PUBLIC INTEREST REVIEW FOR GROUNDWATER APPLICATIONS

SUBJECT: Application G- 17933 Supersedes review of n/a
Date of Review(s)

A. GENERAL INFORMATION: Applicant's Name: Shawn Ueda County: Multnomah

A1. Applicant(s) seek(s) 1.12 cfs from 1 well(s) in the Sandy Basin,
Beaver Creek subbasin Quad Map: Sandy

G-17933 Ueda
T1S/R4E- Section 22

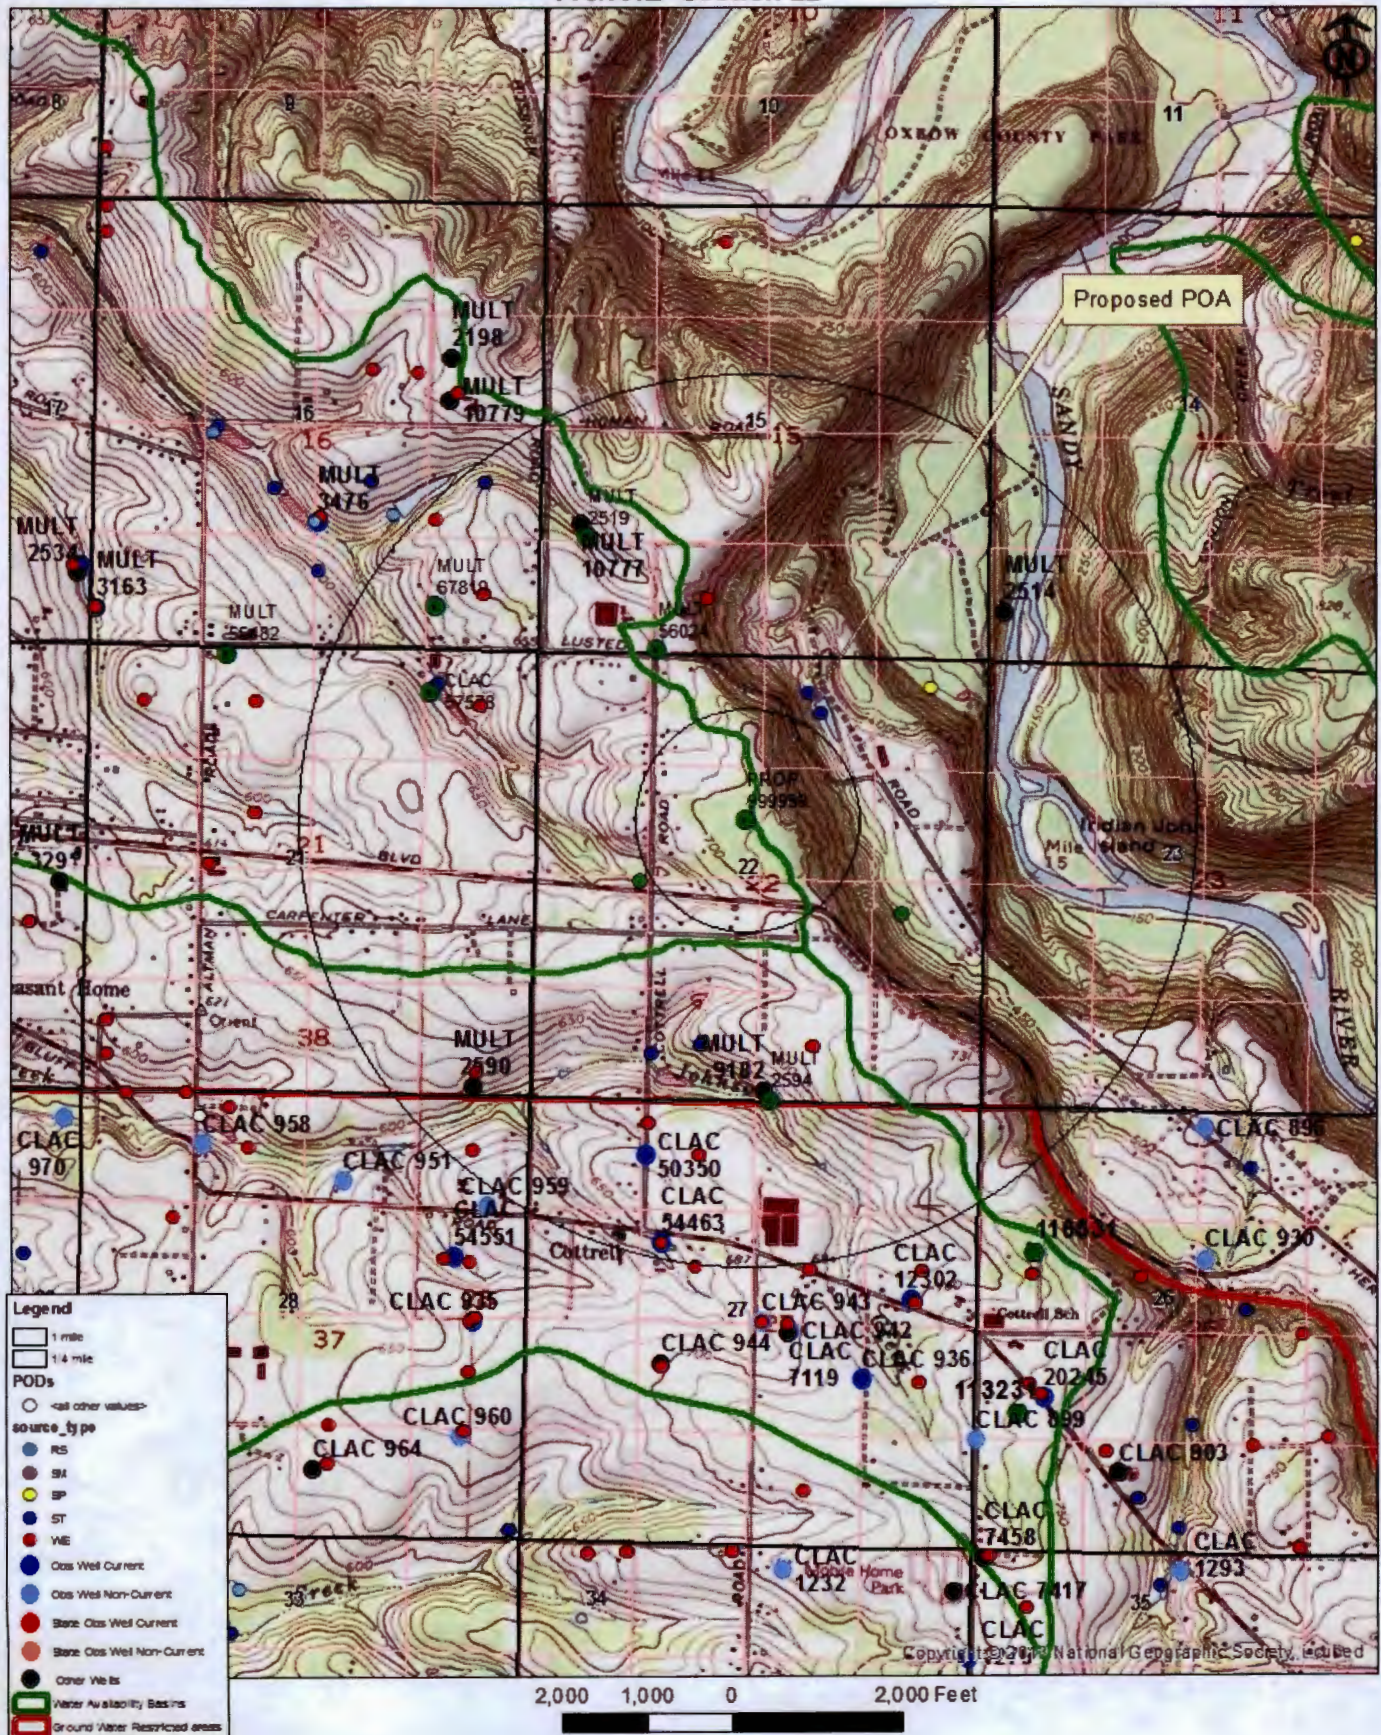
B2c. There are at least two water bearing zones within the Troutdale Formation in this area. The attached hydrograph shows a group of nearby wells with groundwater level elevation around 350 feet above mean sea level (amsl) and a second, deeper group, with water levels around 290 feet amsl. Based on the proposed location and well depth, this well is expected to access the upper water bearing zone and have a static water level around 350' amsl. To meet current well construction standards, and to prevent head loss through commingling, the well should be completed into a single aquifer within the Troutdale Formation.
